WAIVER/CONCESSION

1. DOCUMENT IDENTIFICATION		1.1. Identification of customer: Rolls-Royce Canada Limited		Supplier #:		1.3. Document reference number Customer #: 210256950		1.5. Category: "GE-3656", CAT 2

2.1. Model of product/program: I TRENT		2.2. Part number: TRN14806		Drawing Issue:		2.4. Part Serial Number/Batch/Effectivity Number/Lot Number: (see box 3)		2.5. Quantity: 1	
Contract Number:		2.3. Part Description: CASE, INLET, ASSY OF		2.6. Product Number:		2.7. Work/Purchase Order Number:		2.8. Assembly Serial Number:

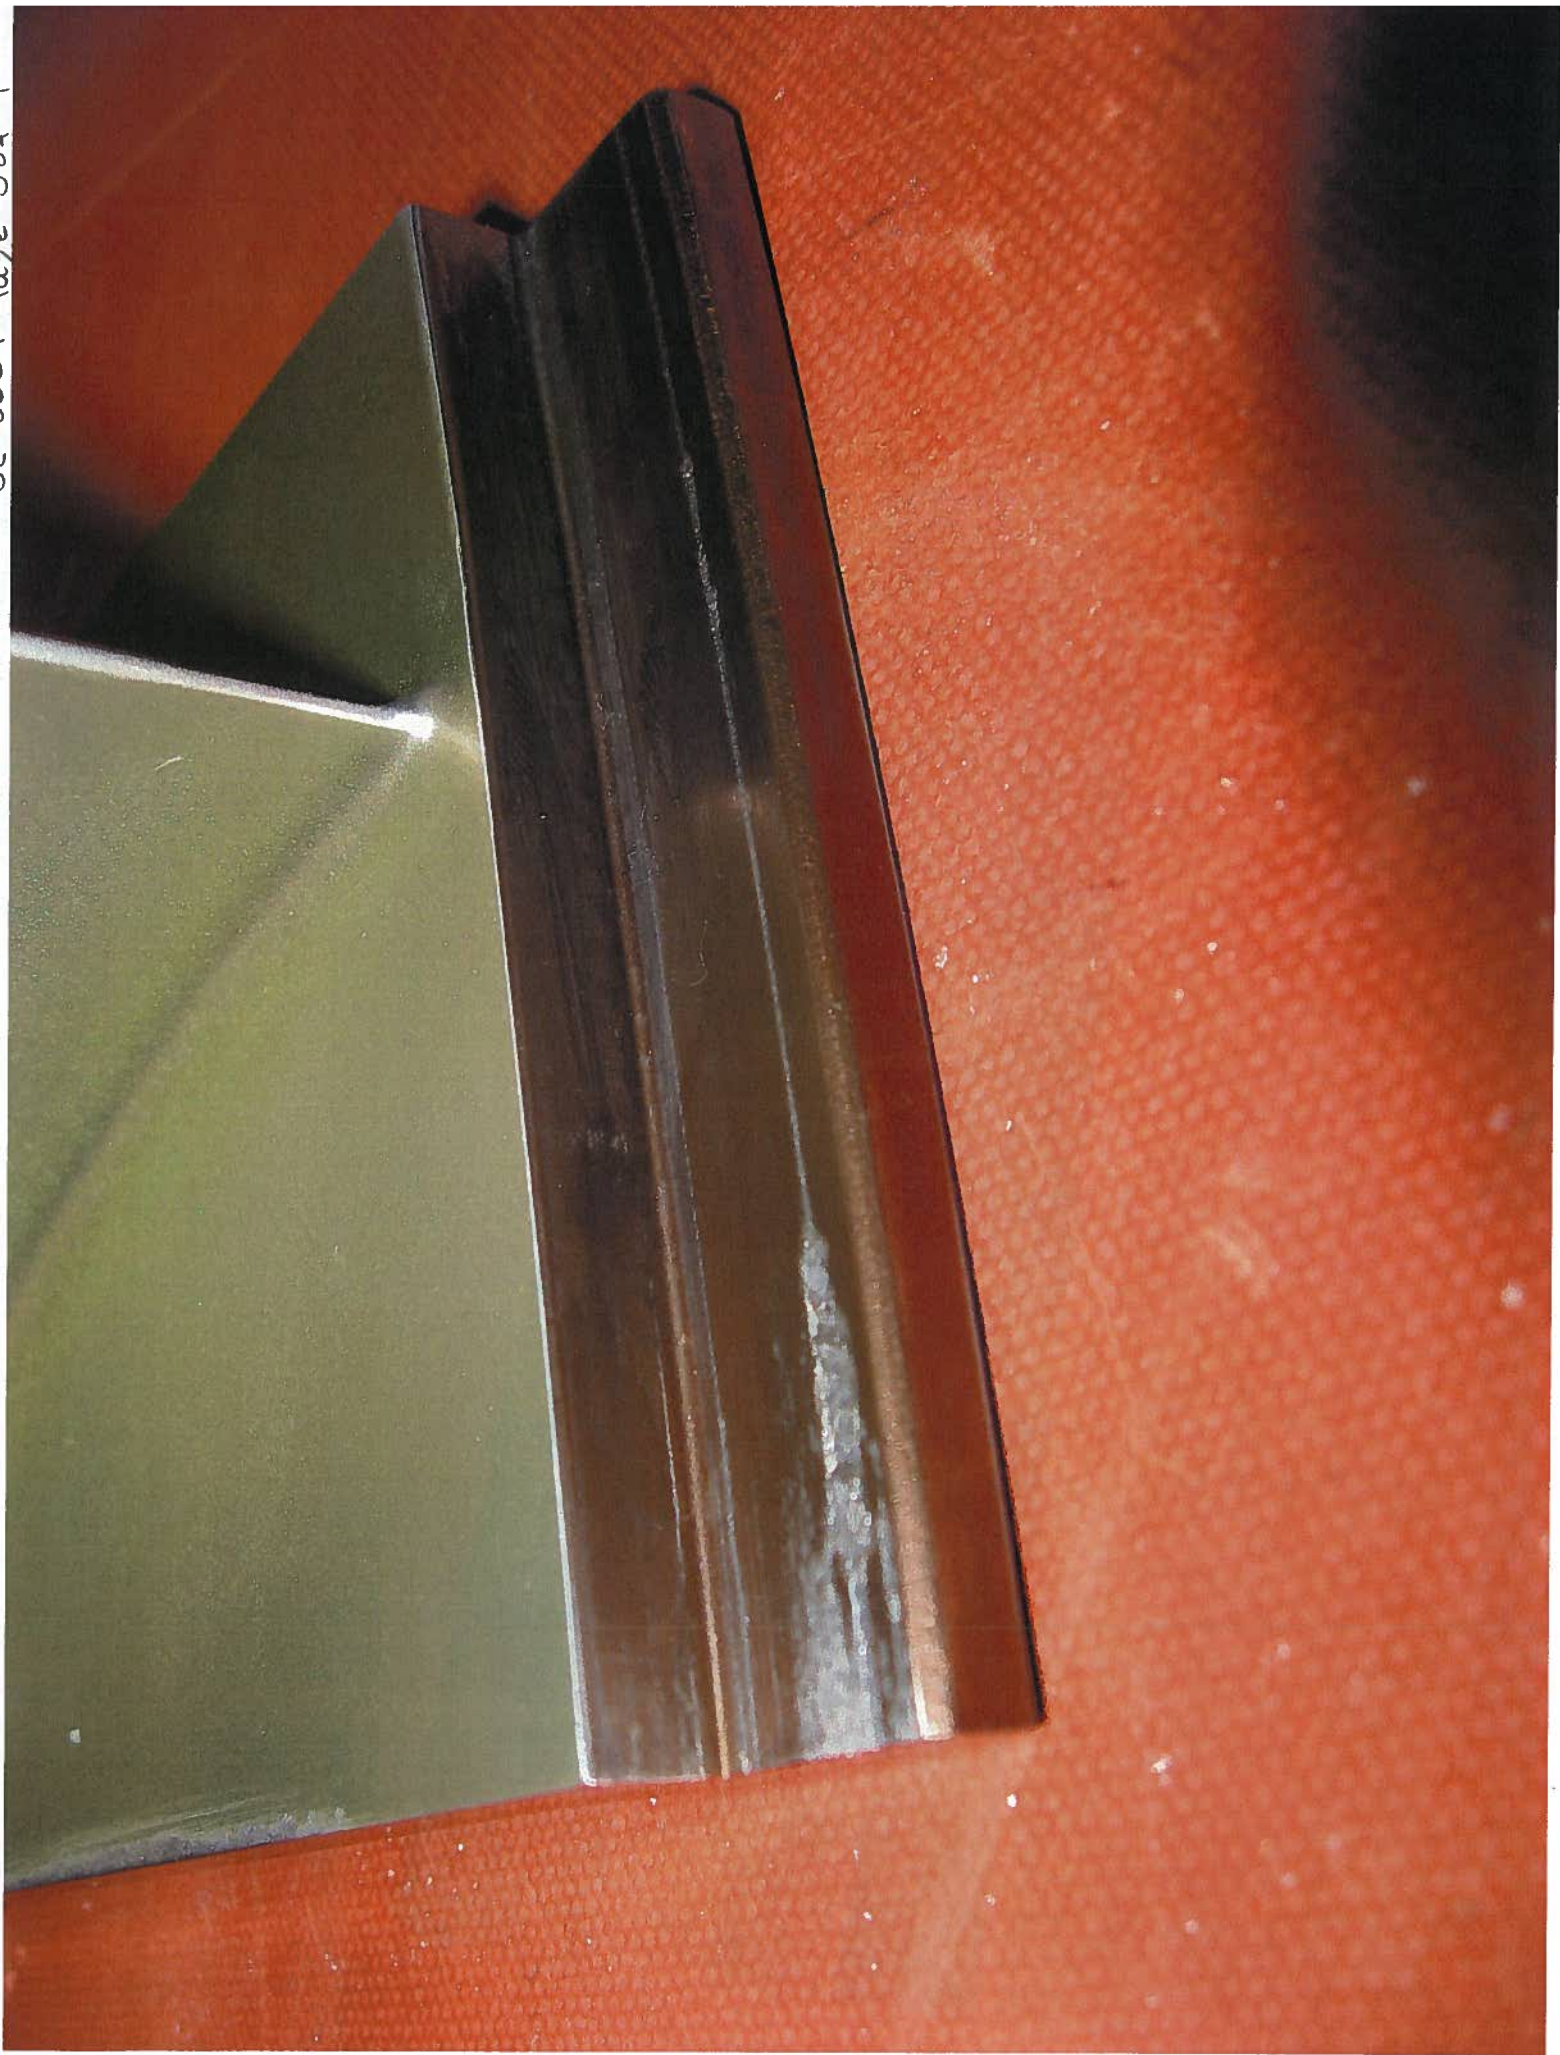
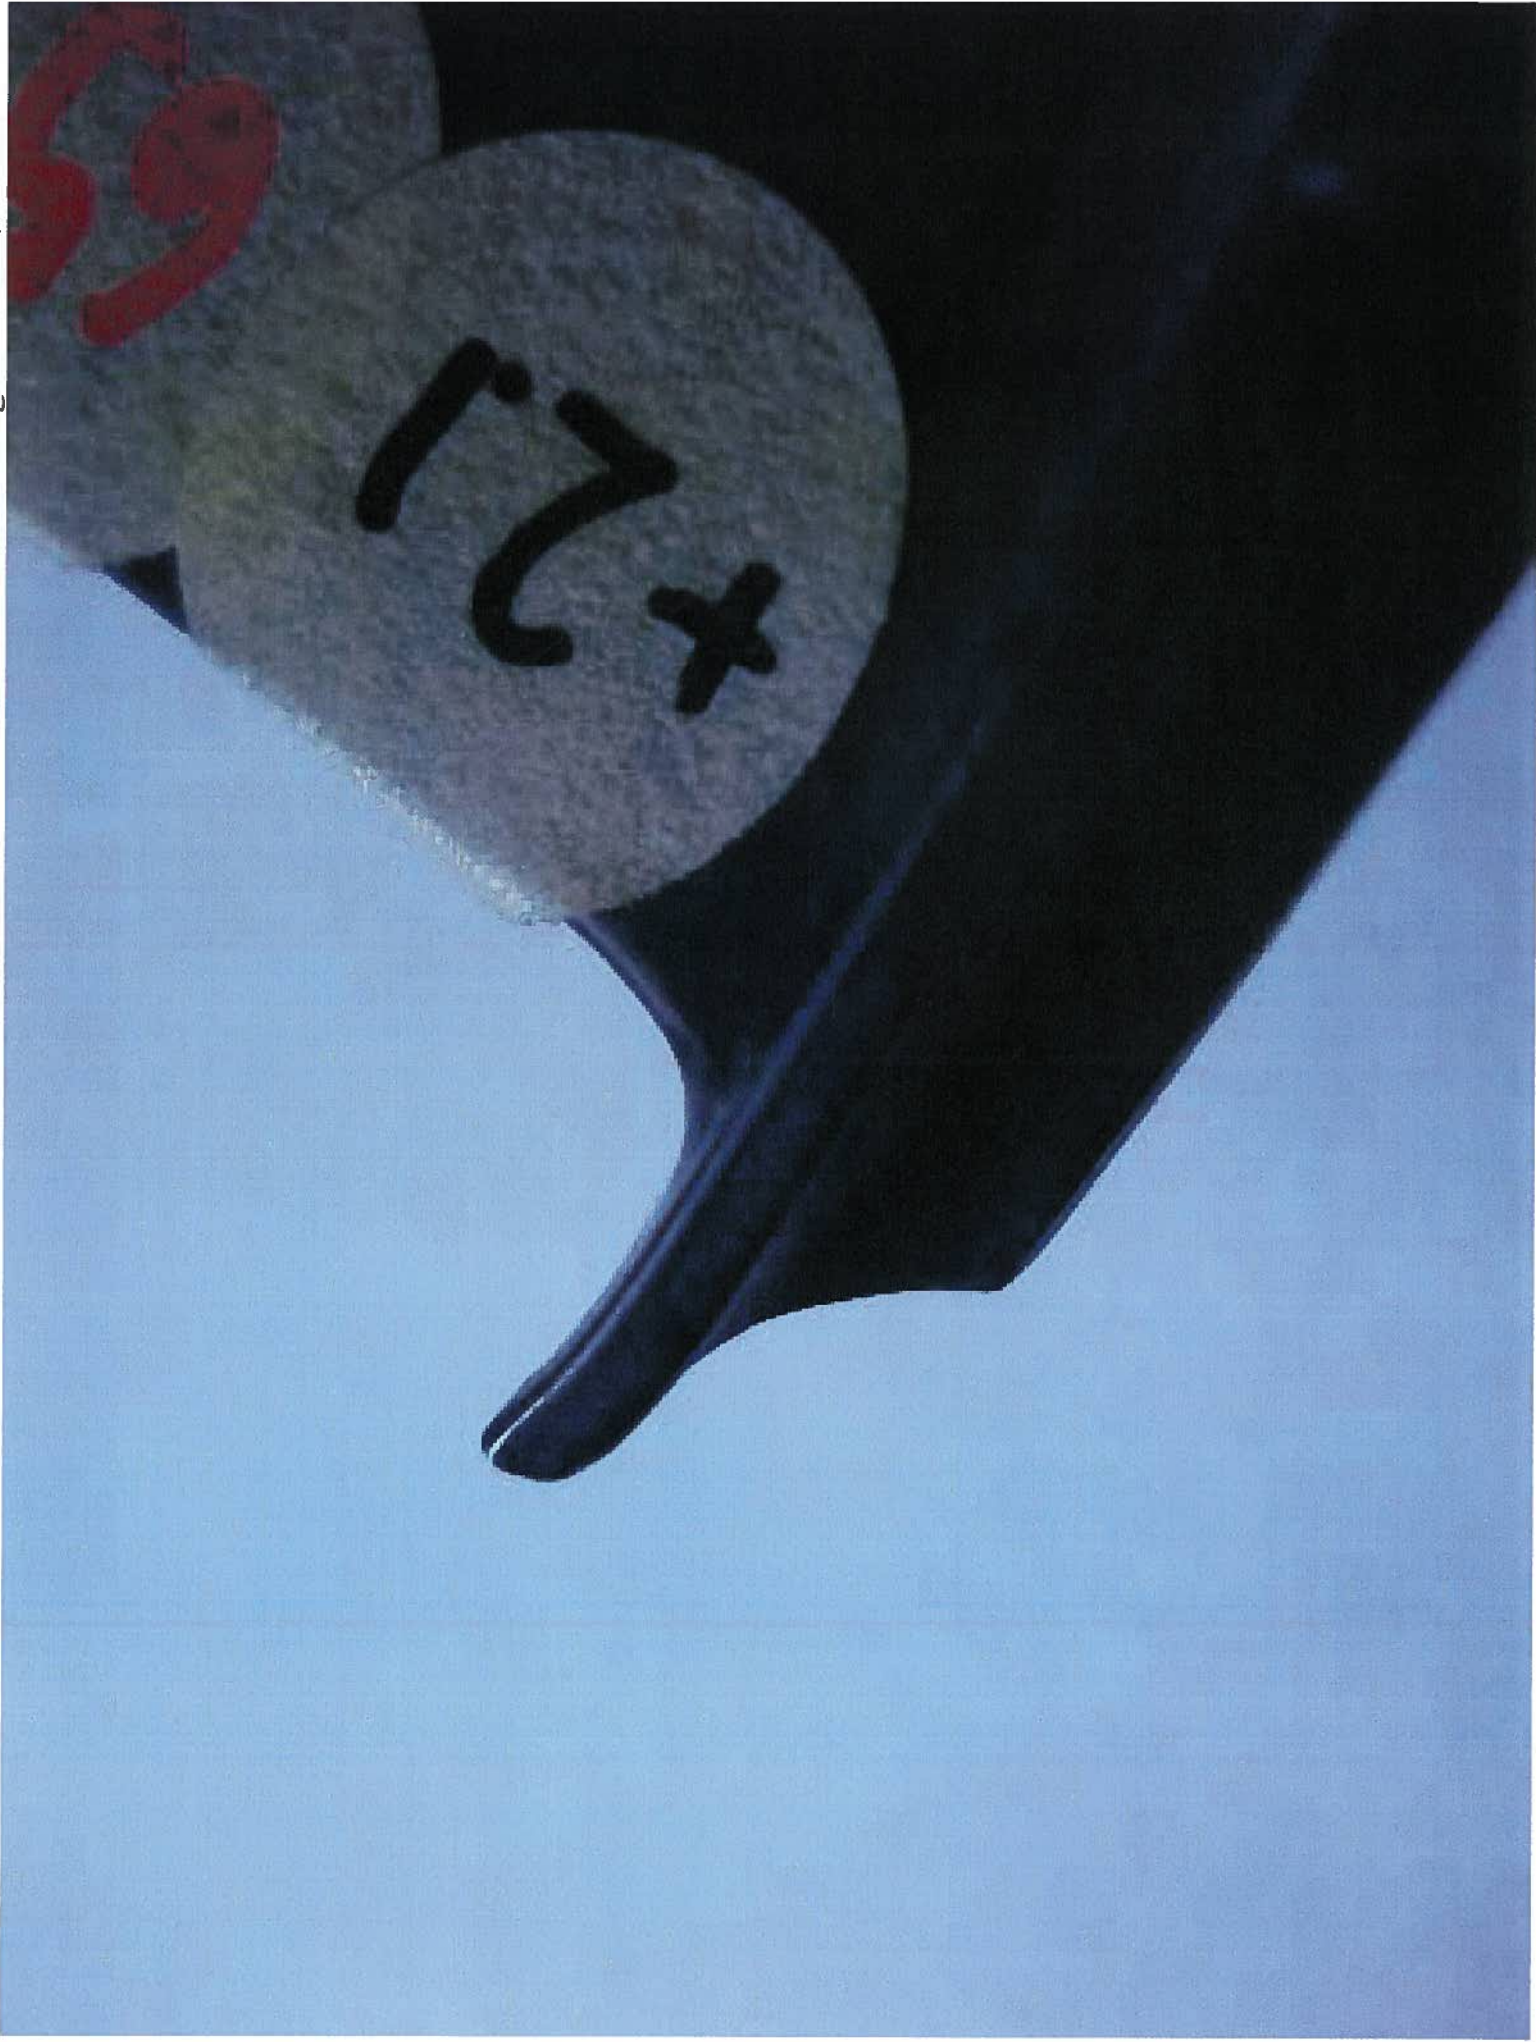
3.1. Detailed Description of the nonconformity		5. DISPOSITION OF NONCONFORMITY					
REF. TRENT ESN057, QN210244311 During LPC Stator Vane assy into LPC Case, the Stator Vane platform picked-up material in the Liner TRN10095. Causing Damage to liner (considered scrap) and to LPC Stator Vane platform (T/E land). The damage is reported as gouge/metal pick-up, measuring 2,0 mm wide by 13,30 mm long and approximately 0,23 mm deep. The damage is located 9,0 mm from Vanes platform edge. Request to repair the Stator Vane platform using EFRS3253. Previous Submissions of a similar nature: 1006560		5.1. MRB/Design Decision: ACCEPTABLE FOLLOWING REPAIR. CAT 2. NON DELEGATED. MARK "CAT 2, GE-3609" NEXT TO PART NUMBER. Quality Decision:

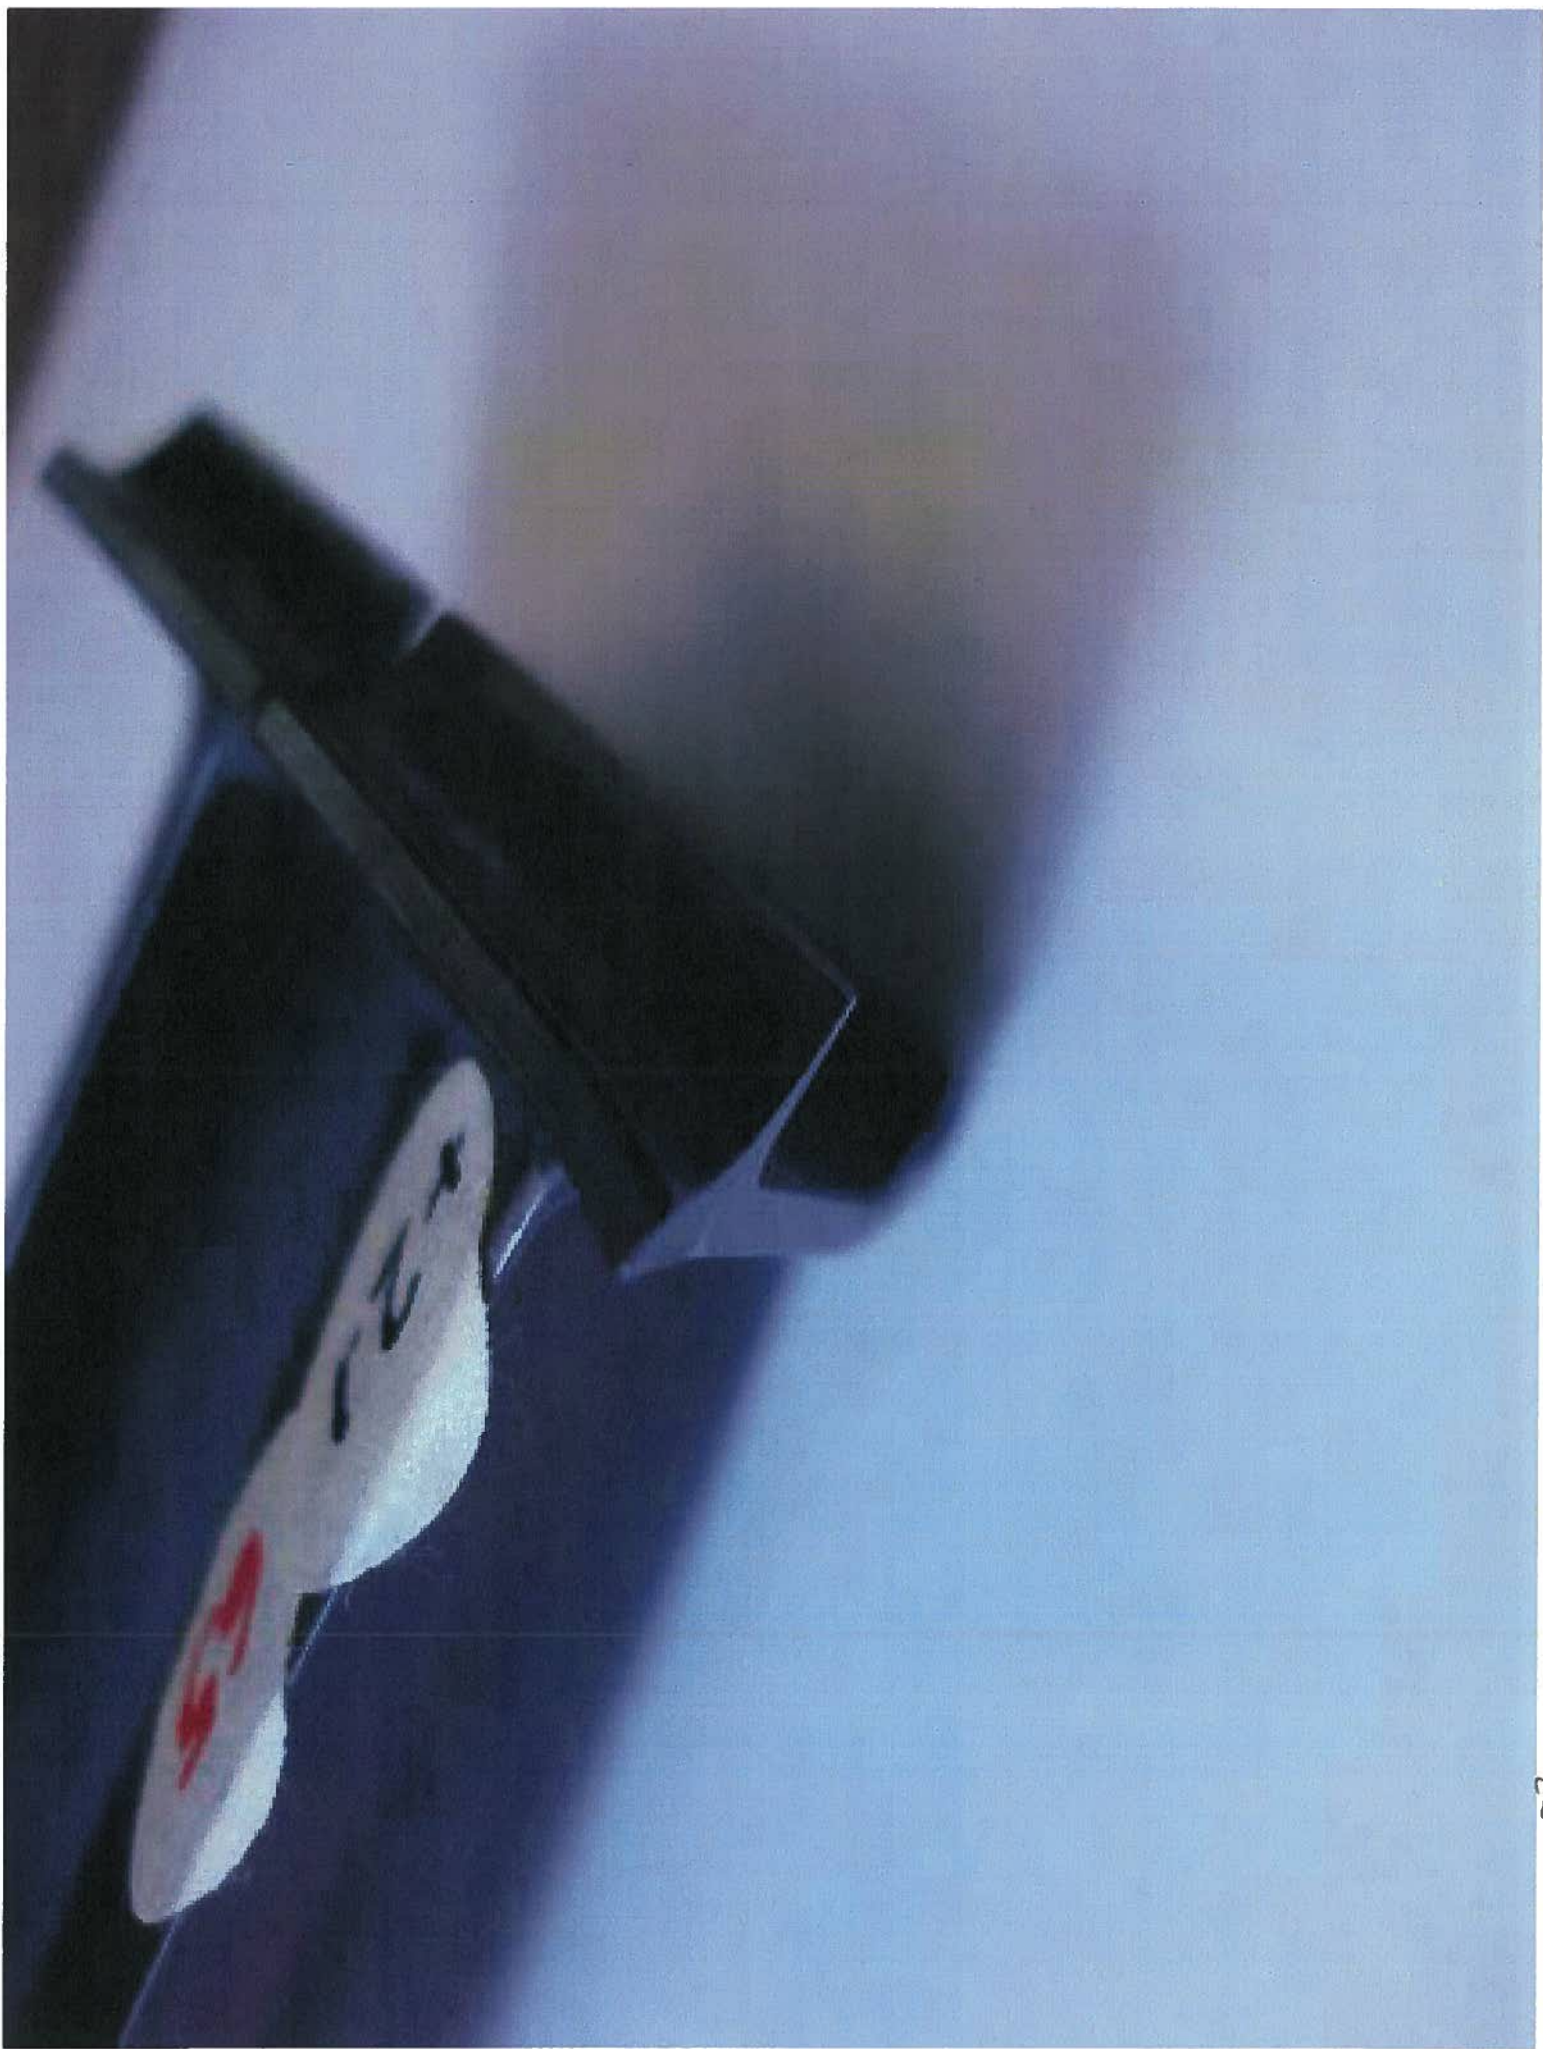
3. DESCRIPTION OF NONCONFORMITY		5. DISPOSITION OF NONCONFORMITY							
3.1. Detailed Description of the nonconformity		Life Data:							
ESN058 QN210244791 QTY 1 OFF BLADE LPT STAGE1 IS BENT ON THE OUTER PLATFORM CORNER ADJACENT TO THE TRAILING EDGE AND MEASURES APPROX 0.205" LONG BY 0.160" WIDE THAT DISPLACES THE PROFILE ROUGHLY 0.045" REQUEST TO POLISH TO REMOVE BENT AREA OF BLADE AND CRACKTEST AS PER TSD 594J OP 210.		5.1. MRB/Design Decision: <i>Acceptable as is, Cat 2, Non-Delegated</i> <i>Polish is not required, Crack test by local FPI only.</i> <i>Mark concession number "Cat 2 GE-3611" next to part number.</i> Quality Decision:							
Previous Submissions of a similar nature:		Previous Submissions to actual item:

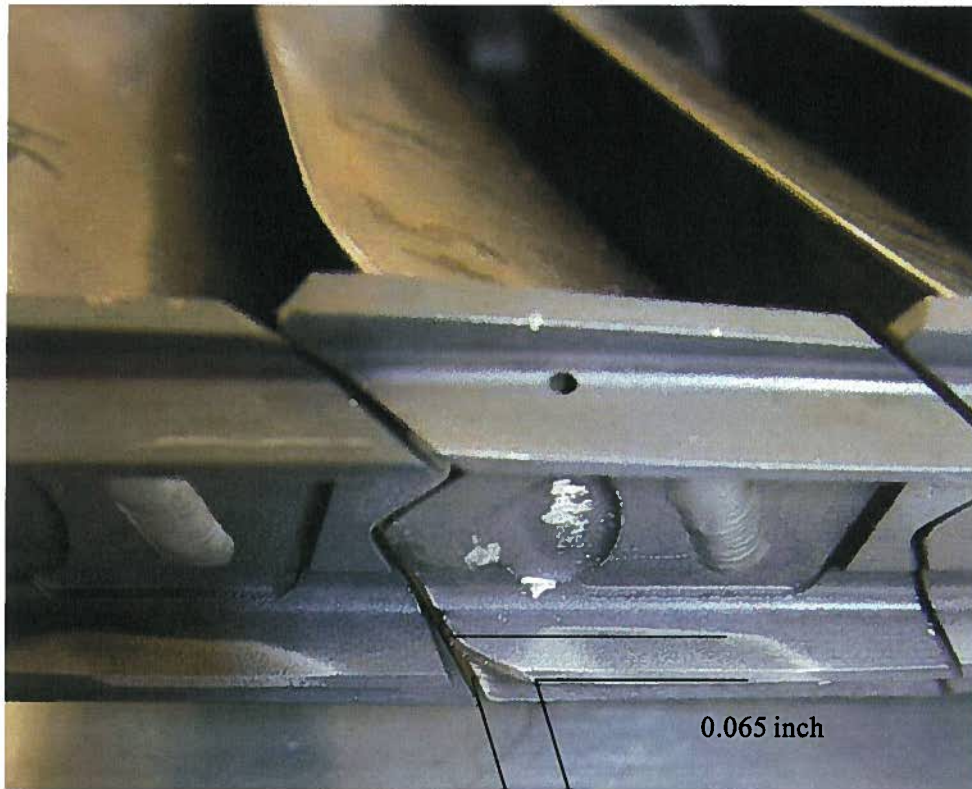
3. DESCRIPTION OF NONCONFORMITY Engine 55, Z1 210238032		5. DISPOSITION OF NONCONFORMITY Life Data:							
3.1. Detailed Description of the nonconformity 1 off blade found with a forward Seal fin corner damaged (broken off). Refer to attached picture for sizes. Request permission to blend damage area and seal fin corner on adjacent blade to even off transition and create a scallop shape dressing. Locally FPI as per TSD594-J OP210 (Omat632) and accept. Previous Submissions of a similar nature: Previous Submissions to actual item:		5.1. MRB/Design Decision: Acceptable to blend only the damaged area of seal fin, CAT2 / Non-delegated . Blending the adjacent seal fin corner is not necessary. Record concession "CAT 2. GE-3586" into engine log book, if marking next to part number or on top of shroud is not possible.
